SUFUN0000728- CURB SPACE CAFE
WITH OVERHEAD WEATHER
PROTECTION

SIDE VIEW

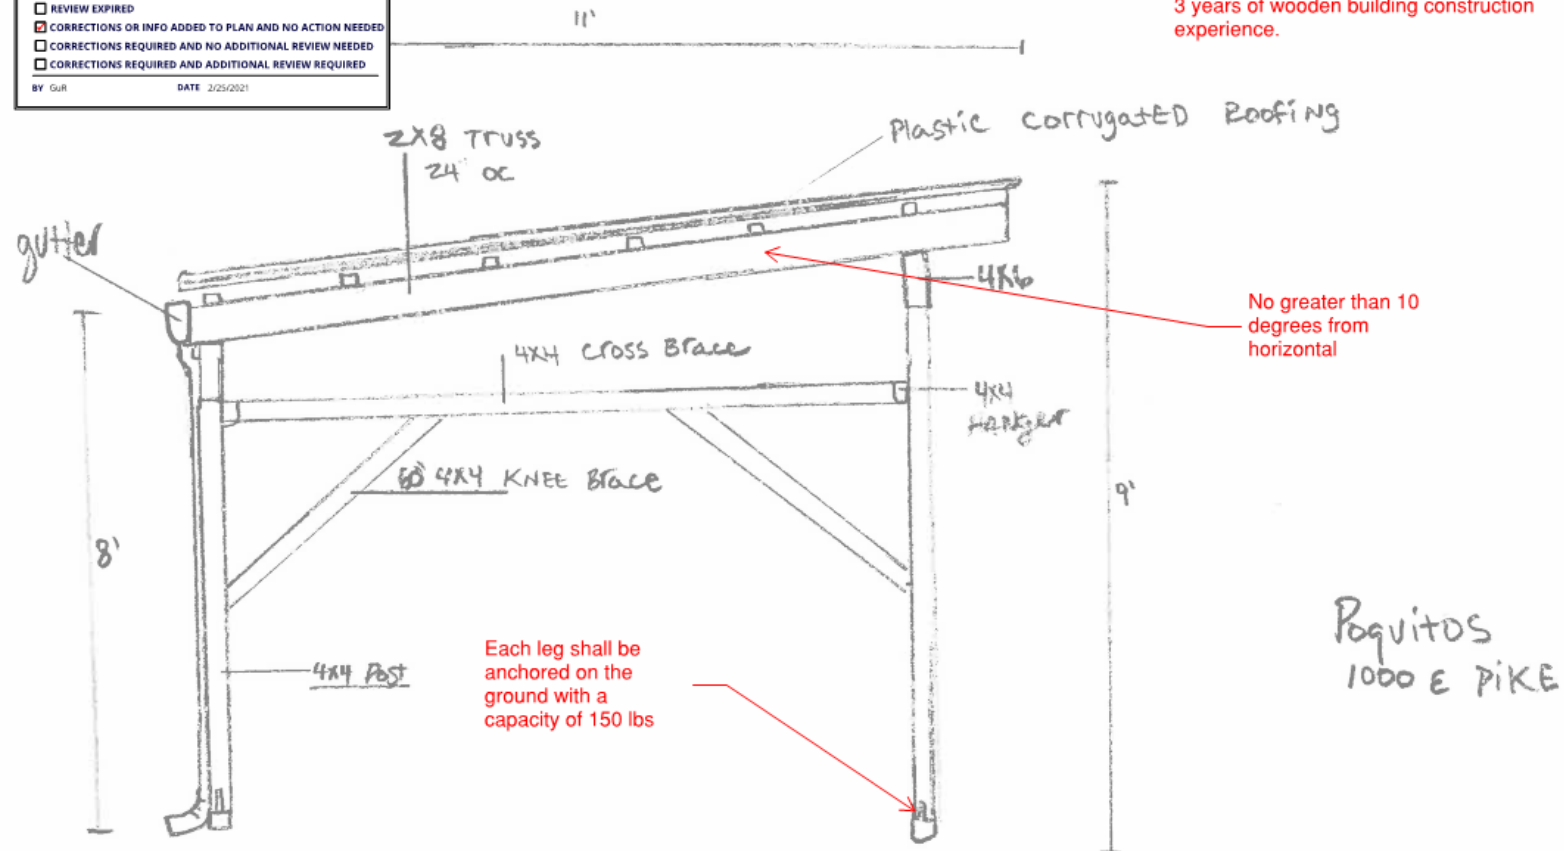
ACCELA STATUS	
<input type="checkbox"/>	NO ACTION
<input type="checkbox"/>	REVIEW EXPIRED
<input checked="" type="checkbox"/>	CORRECTIONS OR INFO ADDED TO PLAN AND NO ACTION NEEDED
<input type="checkbox"/>	CORRECTIONS REQUIRED AND NO ADDITIONAL REVIEW NEEDED
<input type="checkbox"/>	CORRECTIONS REQUIRED AND ADDITIONAL REVIEW REQUIRED
BY GJR DATE 2/25/2021
